To:	Commercial Real Estate Management, City of Toronto Metro Hall 2nd floor 55 John Street Toronto ON M5V 3C6	Addendum No:	05
		Project No:	21025 211018
Attention:	Bonita Lee	File No:	6-2-1
		Date:	November 28, 2024
		Pages (with cover):	22
Project:	Metro Hall Toronto Early Learning Child Care Centre	Delivery:	Electronic

1.1 Addendum No. 05

TORONTO
Metro Hall Fire Station &
Early Years Child Care Centre
Renovation

Toronto
Metro Hall Fire Station &
Early Years Child Care
Centre Renovation

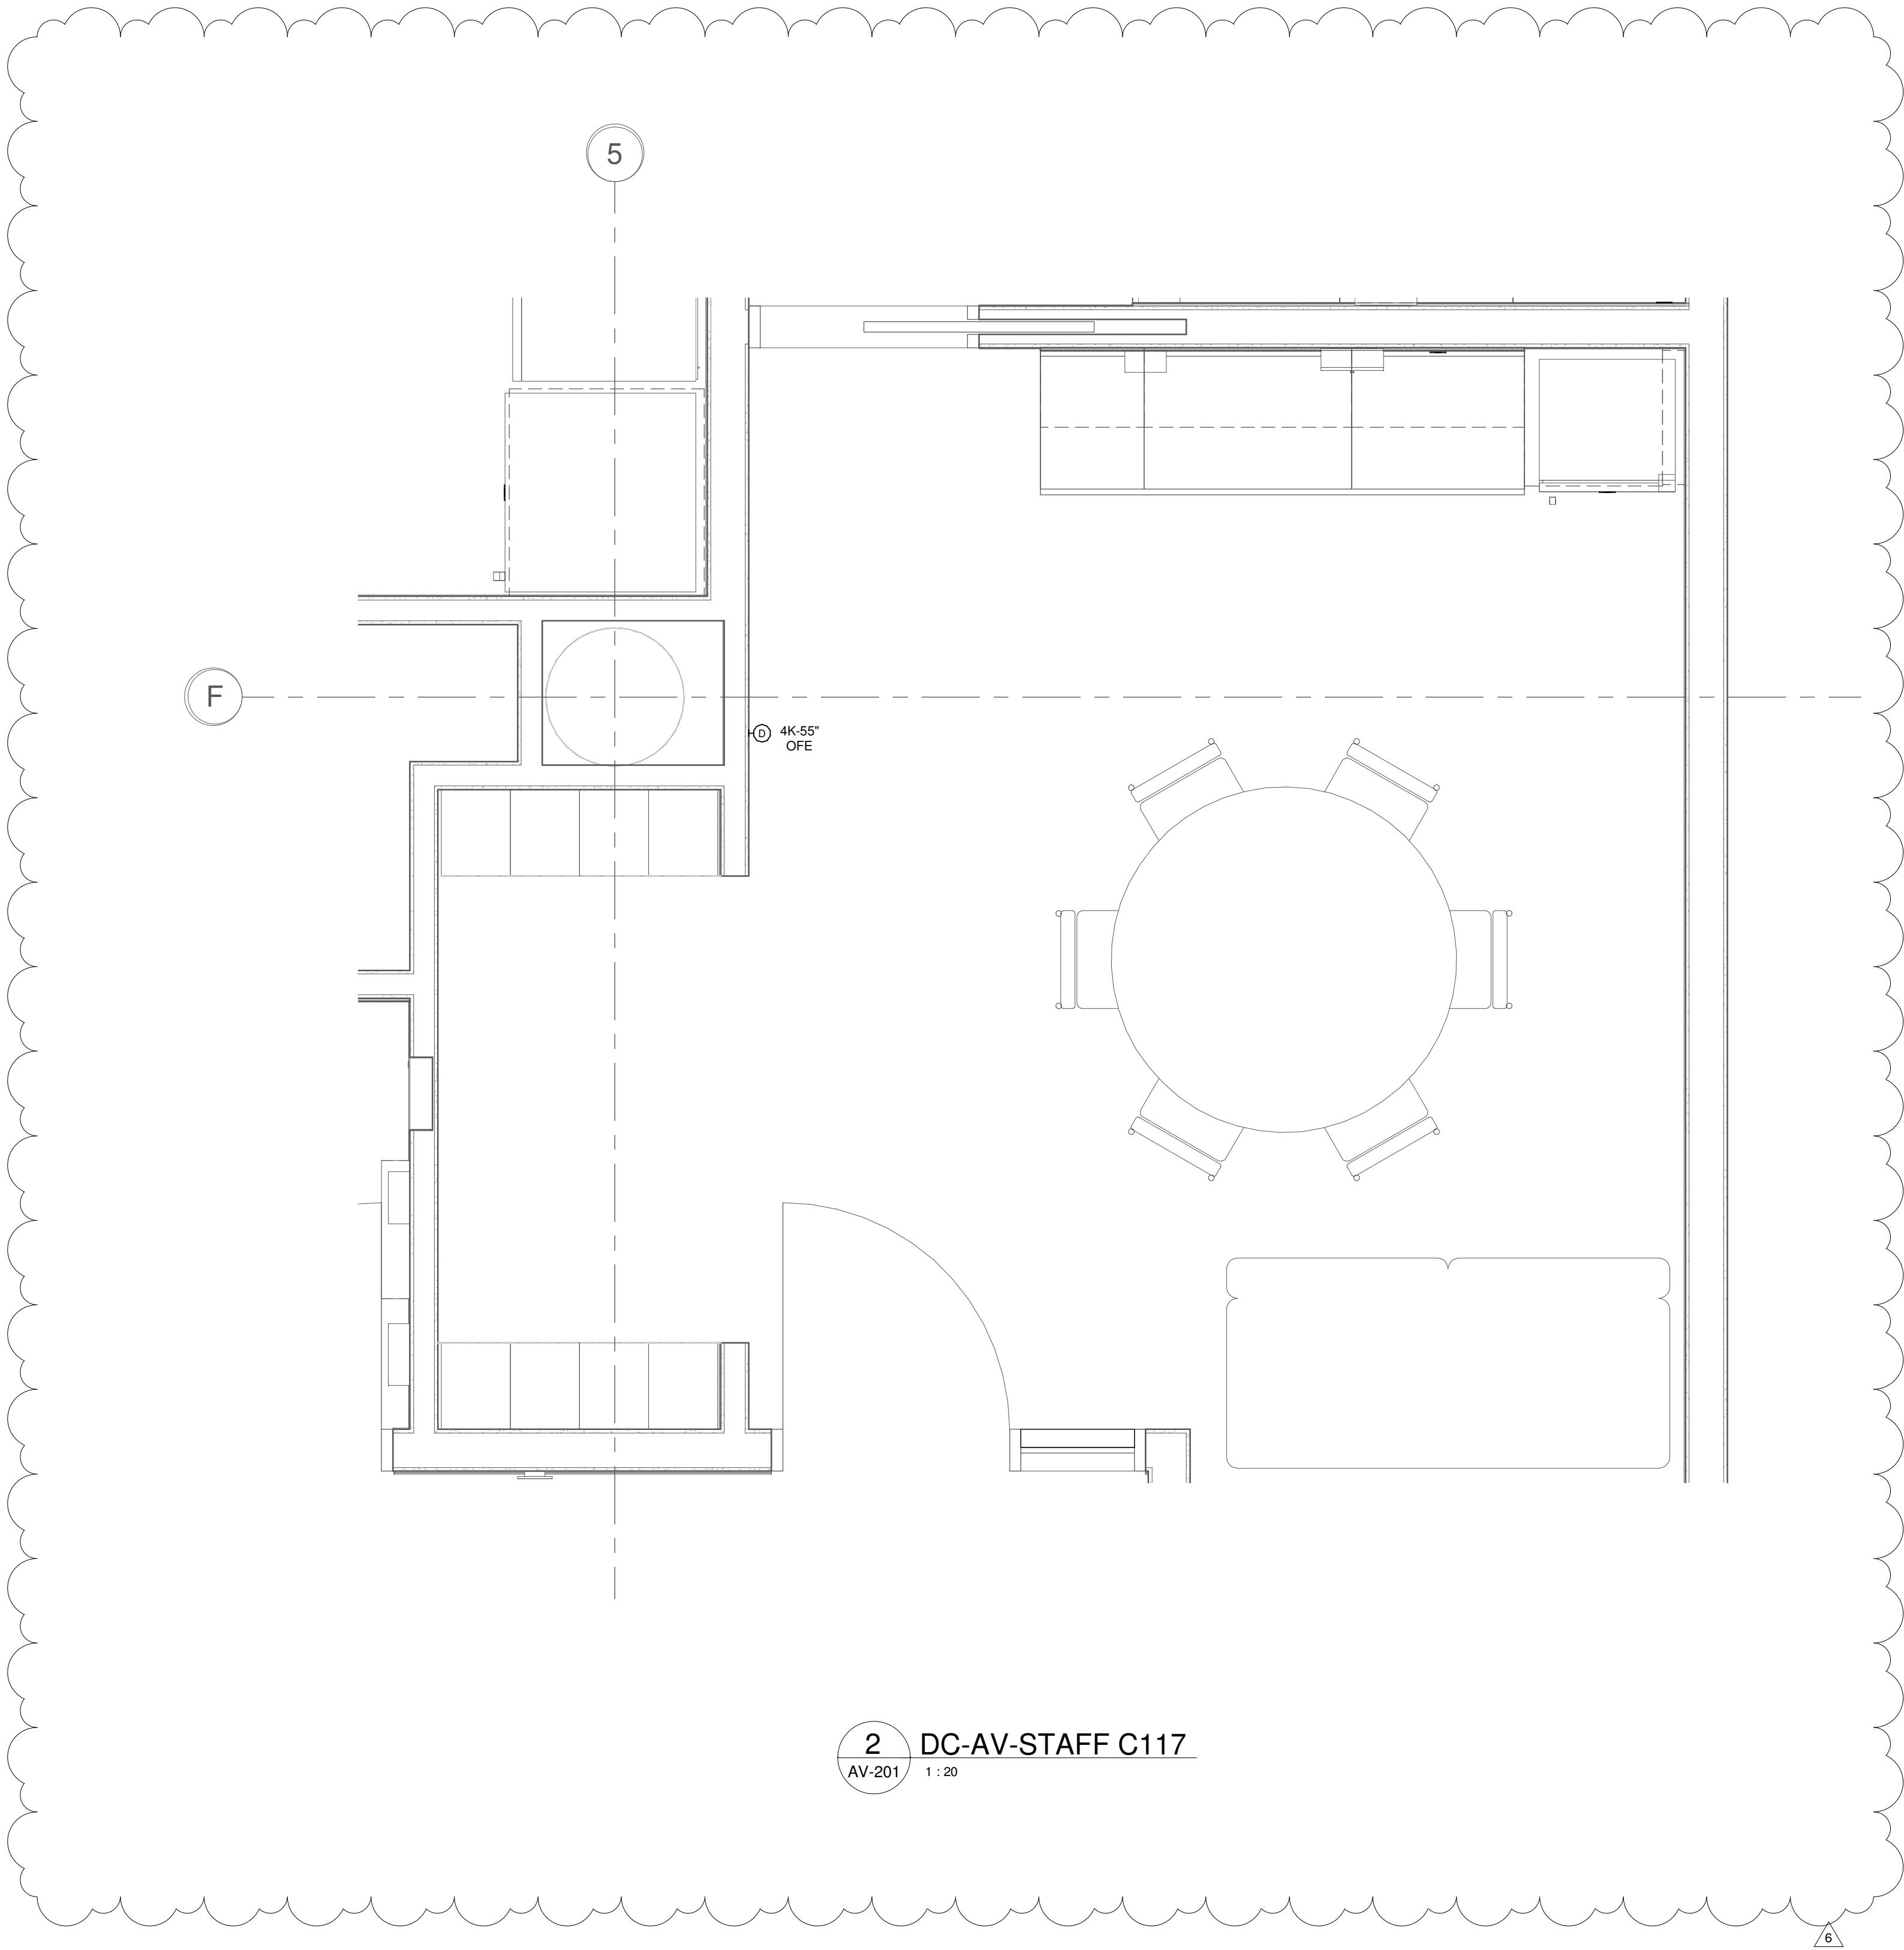
1. Reference: AV-101 – Daycare Audio Visual Layout (Drawing Re-Issued Herewith)

1.1. Add callout “2/AV201” at Staff [C117]

2 AV FUNCTIONAL DIAGRAM STAFF ROOM C117
AV-501 NTS

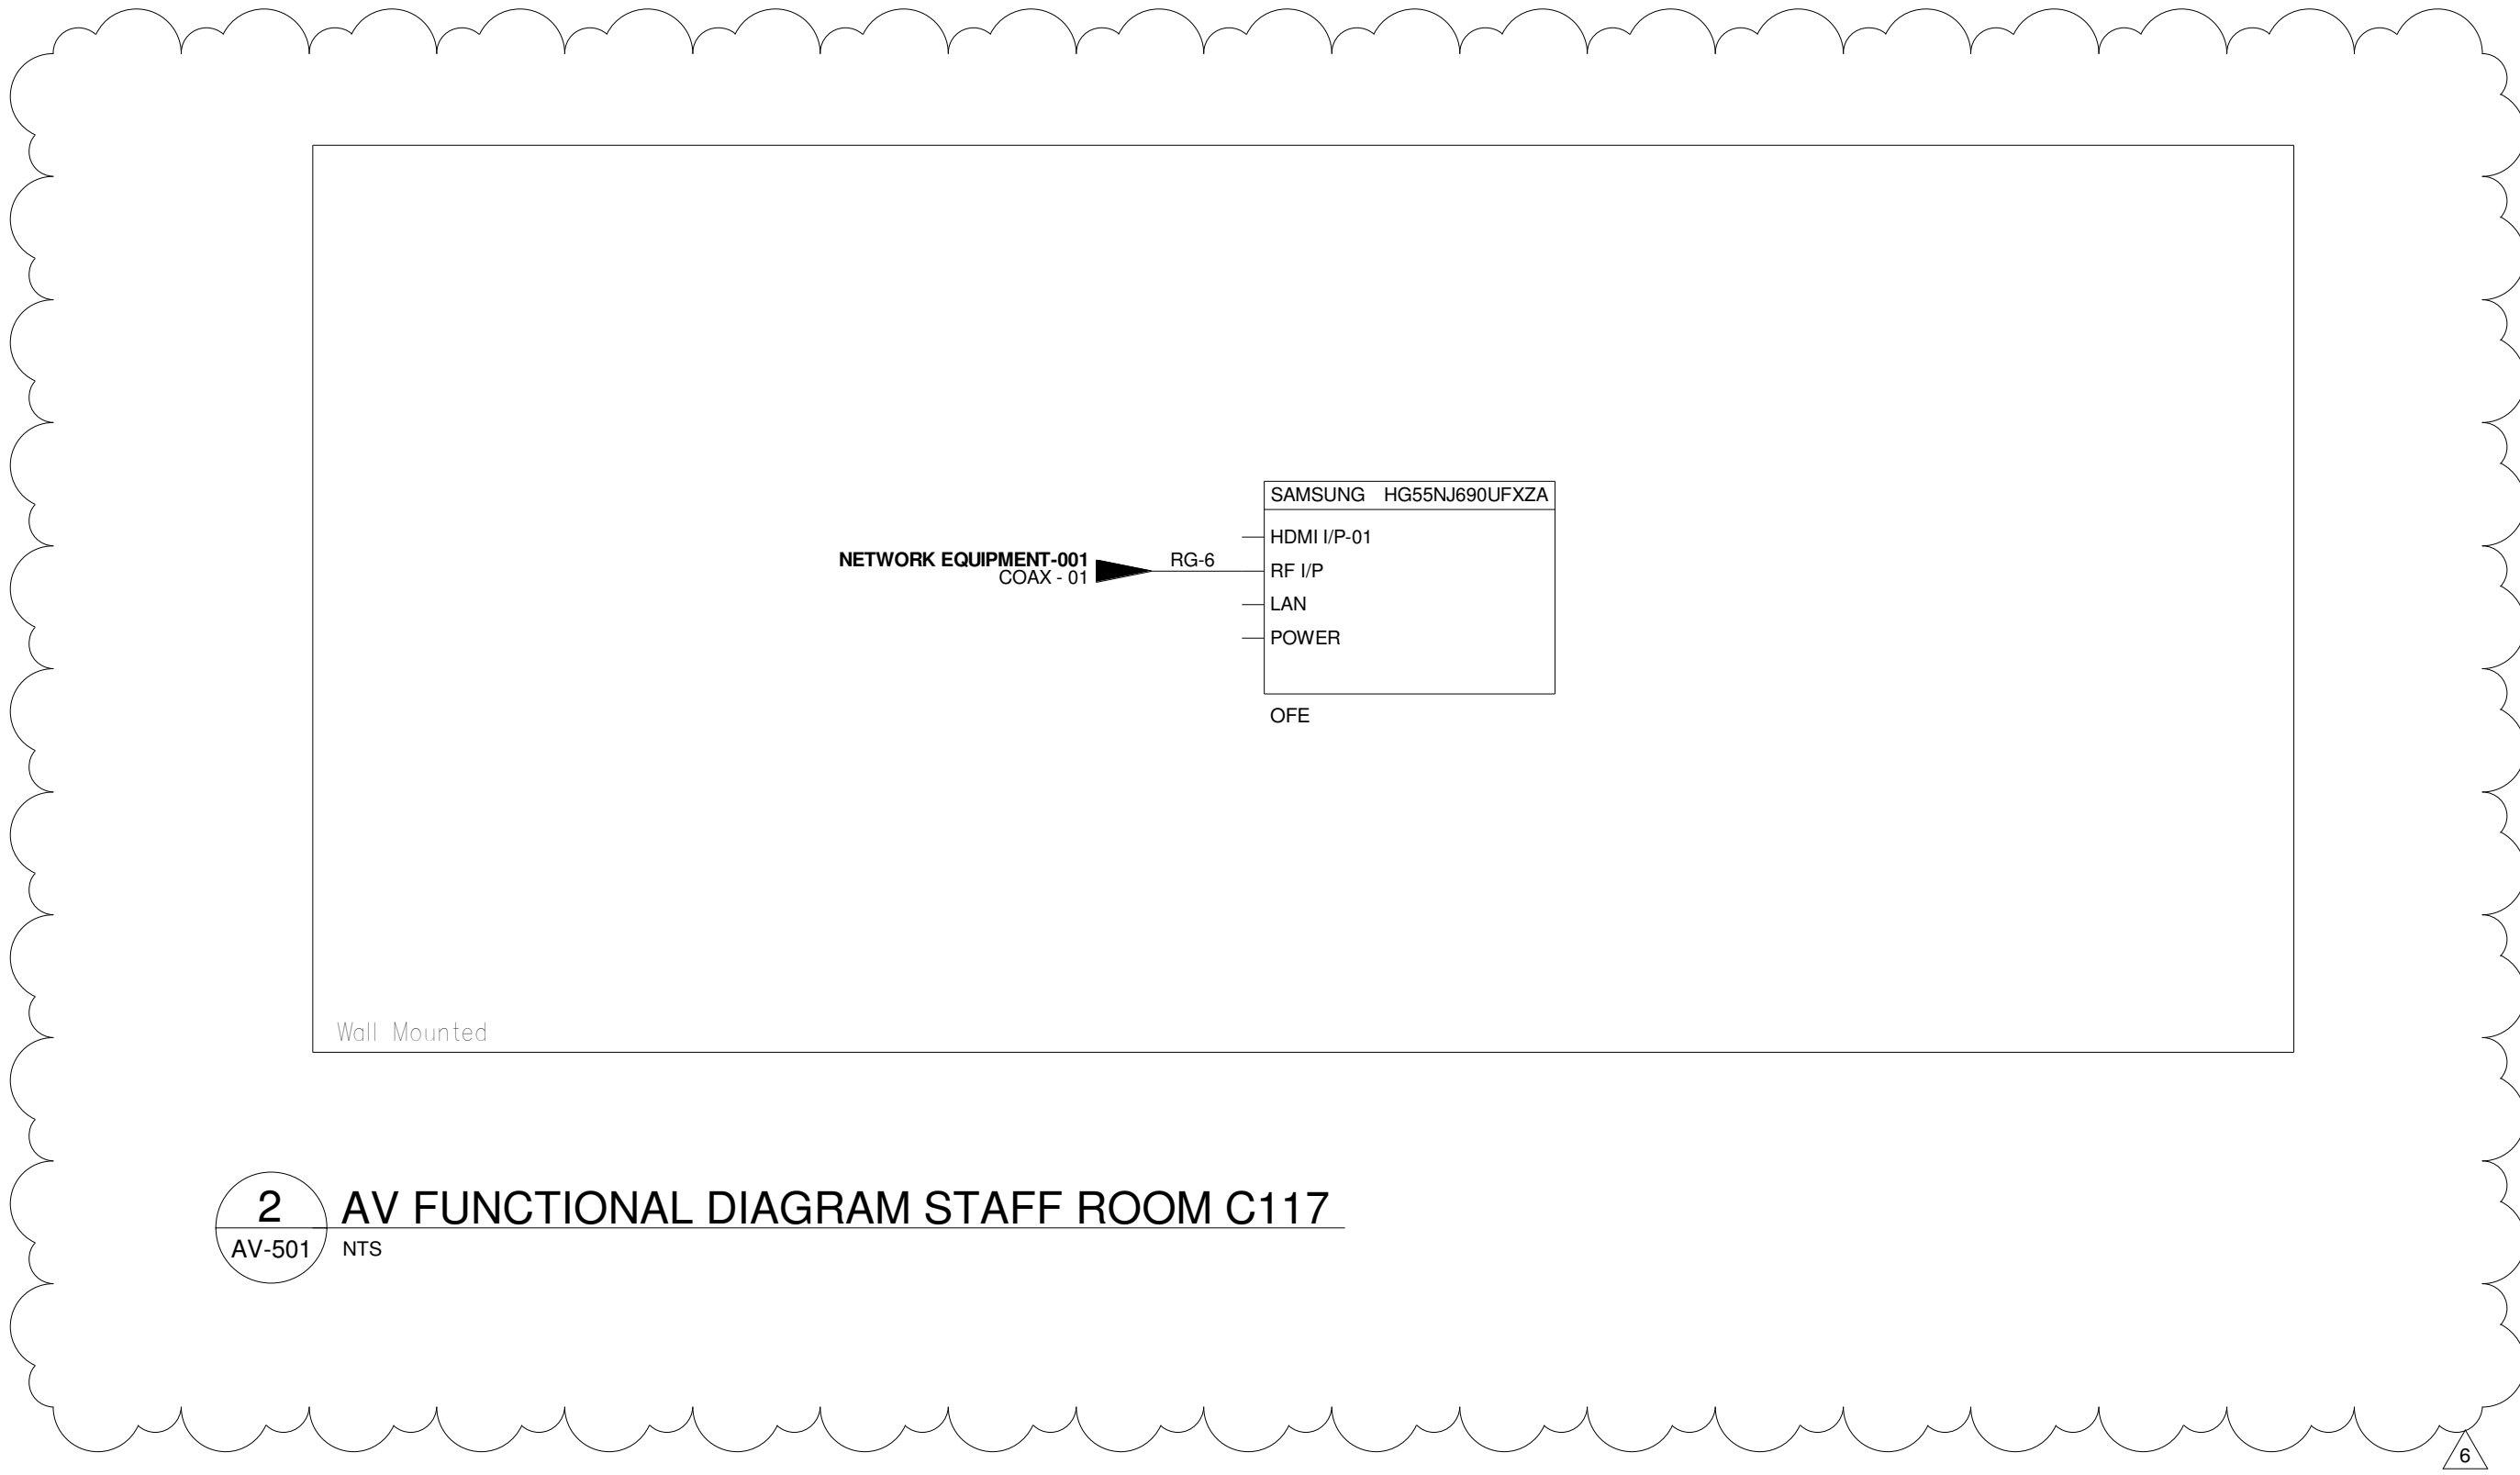
3. Reference: AV-501 – Functional Diagrams (Drawing Re-Issued Herewith)

3.1. Add Detail 02 – AV Functional Diagram Staff Room [C117]

1 AV RISER
NTS

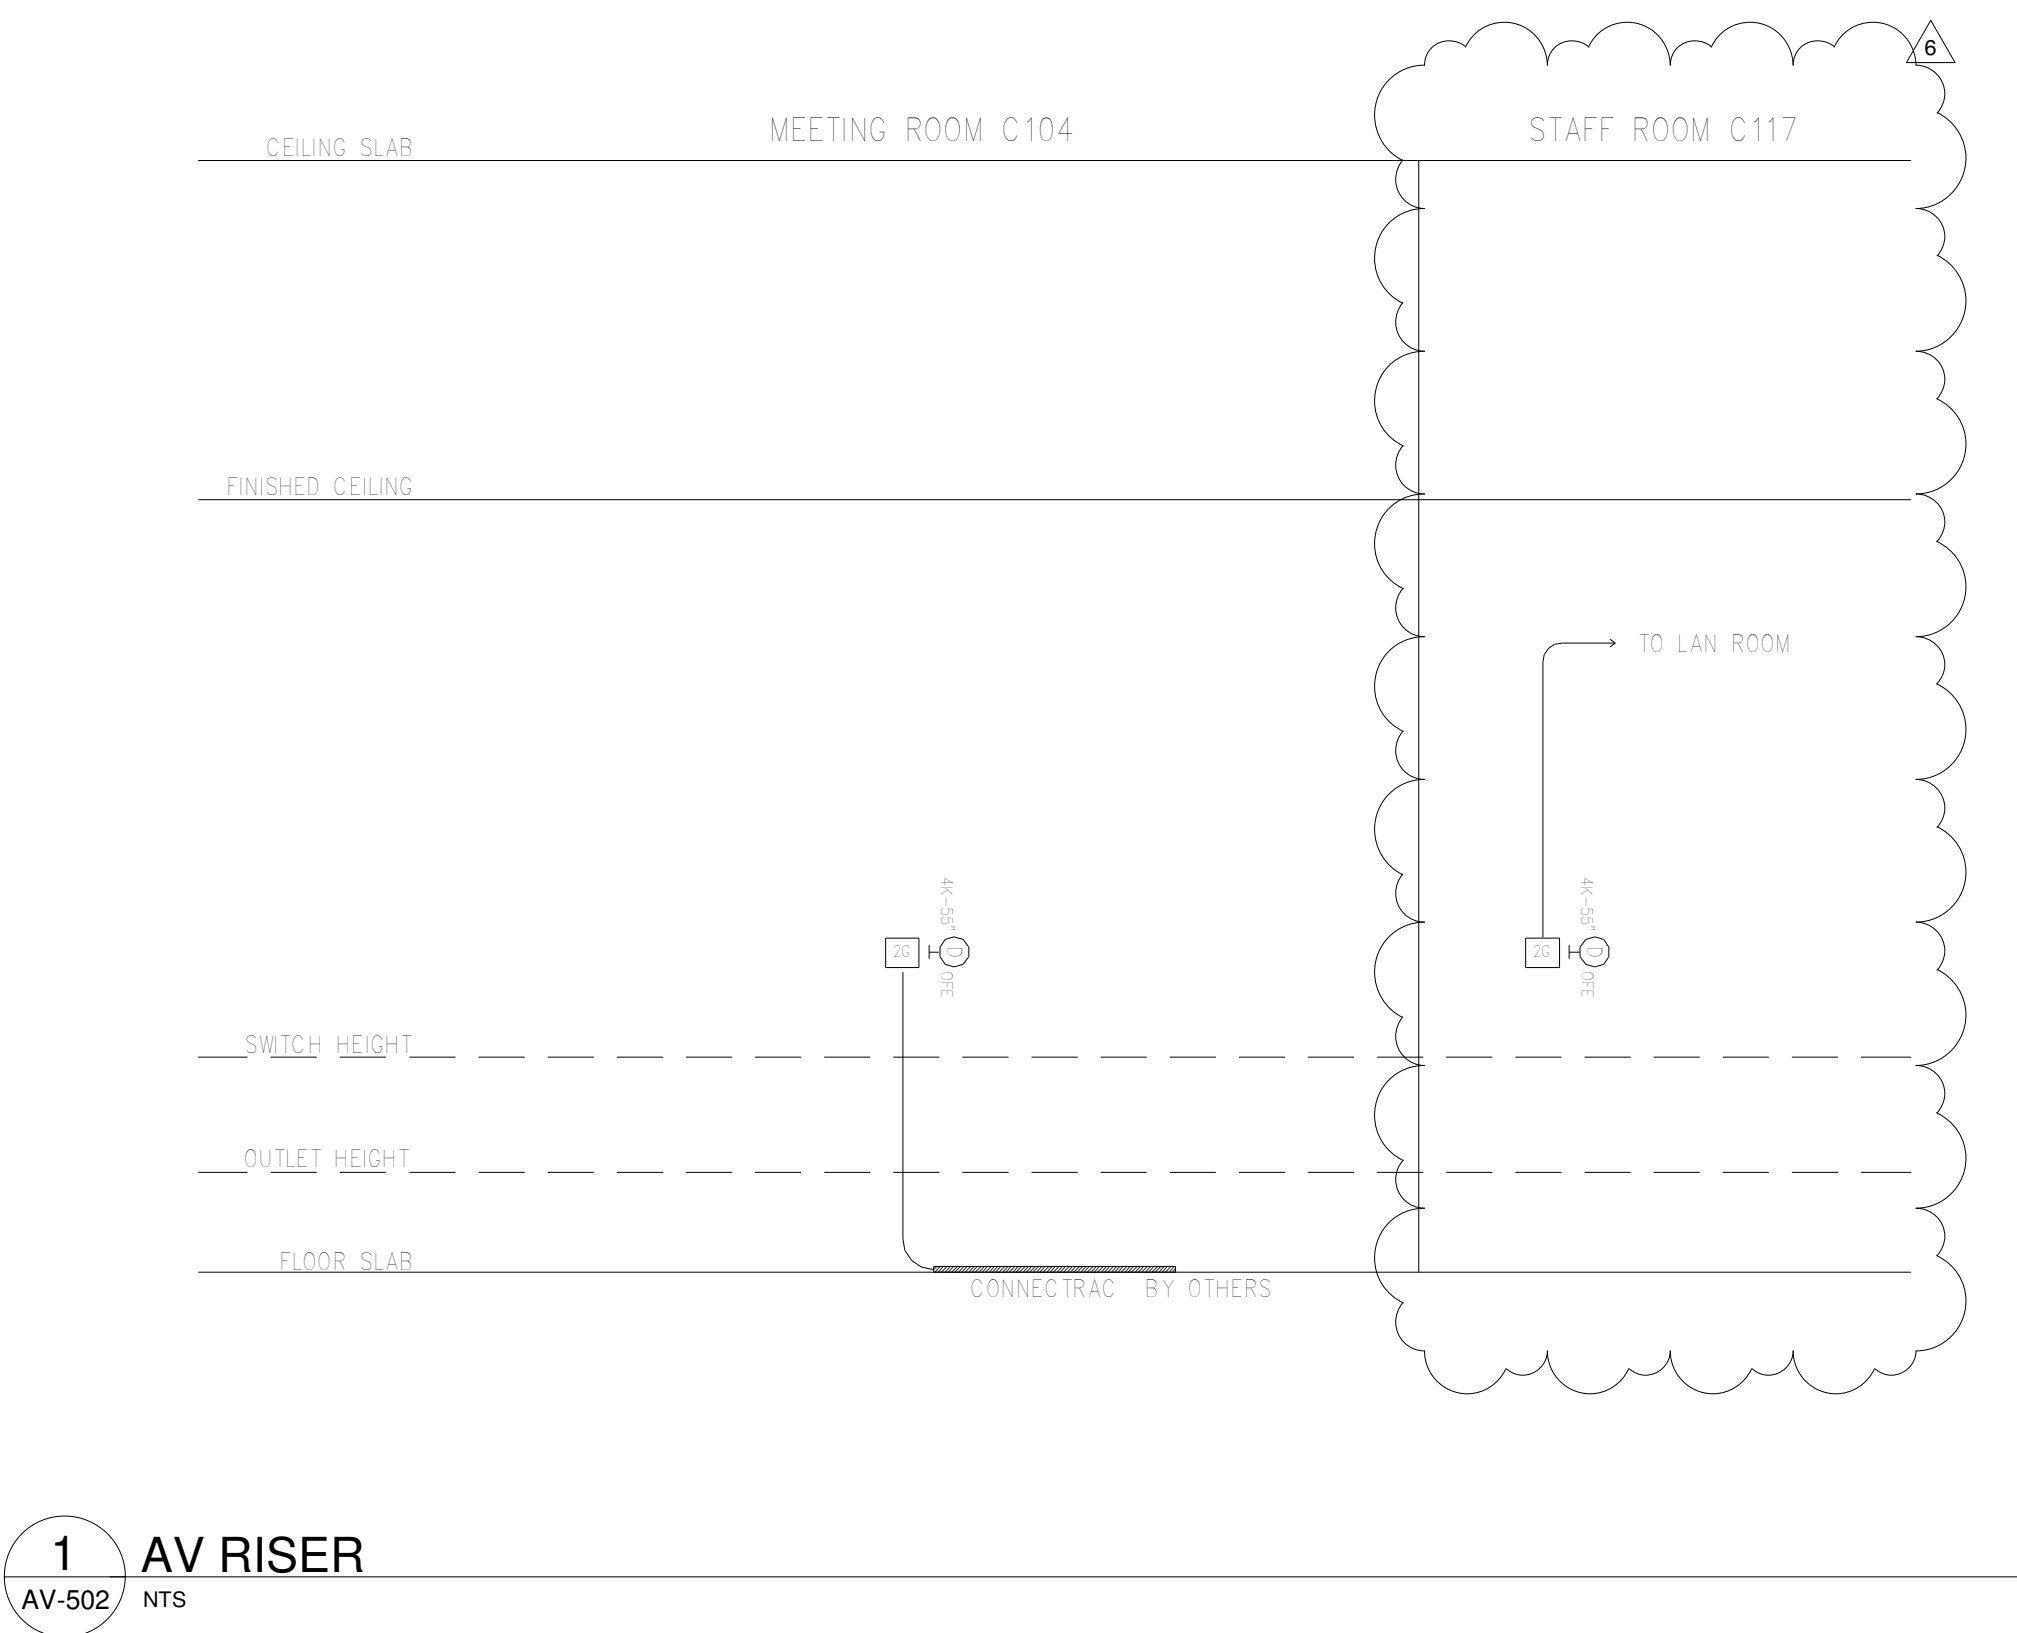
4. Reference: AV-502 – AV Riser (Drawing Re-Issued Herewith)

4.1. Add Staff Room [C117]
